Product Change Notification (PCN)

PCN #: 10L-2026 *Date: October 21, 2026*

Ezurio Part Number	Description
BT860-SA	Module, BT860, Integrated Antenna
BT860-ST	Module, BT860, RF Trace Pin
BT860-SA-T/R	Module, BT860, Integrated Antenna, Tape and Reel
BT860-ST-T/R	Module, BT860, RF Trace Pin, Tape and Reel
DVK-BT860-SA	Development Kit, Module, BT860 Series, Integrated Antenna
DVK-BT860-ST	Development Kit, Module, BT860 Series, Trace Pin

BEFORE	AFTER

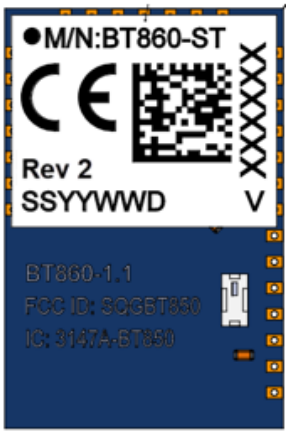
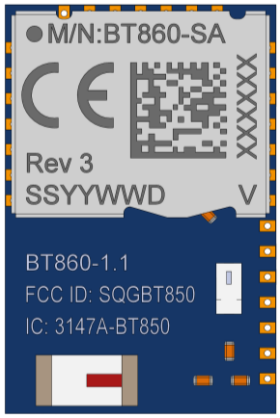
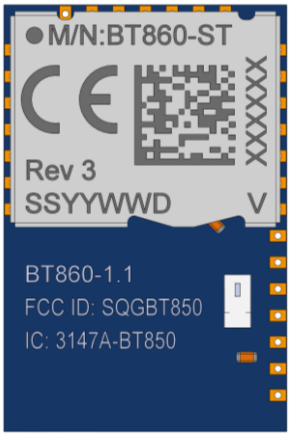
- **BT860-SA, BT860-SA-T/R, BT860-ST, BT860-ST-T/R**
  - Shielding design change: removal of holes from the shield can top surface.
  - On the product information, change from label to laser-etched and change revision from Rev 2 to Rev 3.

BEFORE	AFTER

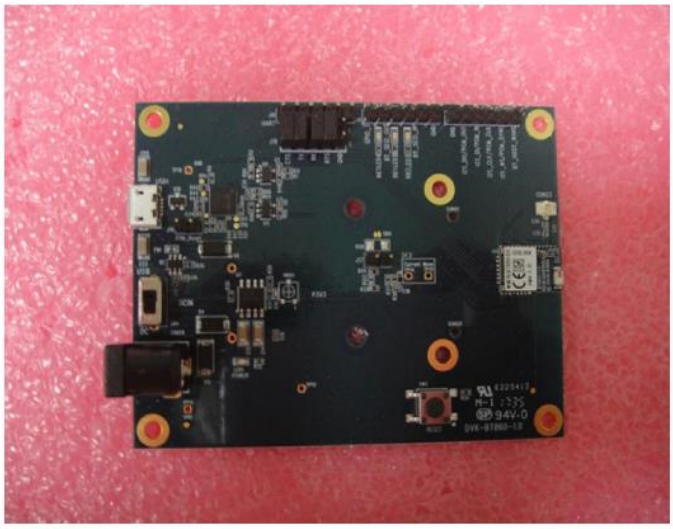
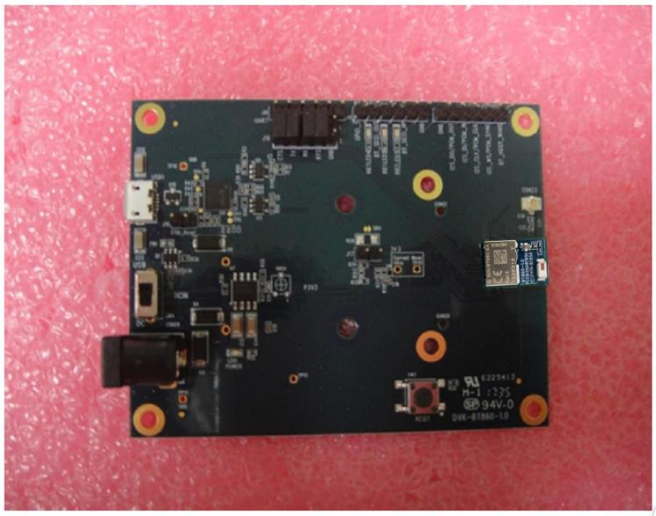
- **DVK-BT860-SA/DVK-BT860-ST**
  - On the PCBA:
    - Change the fitted module from label to NO label
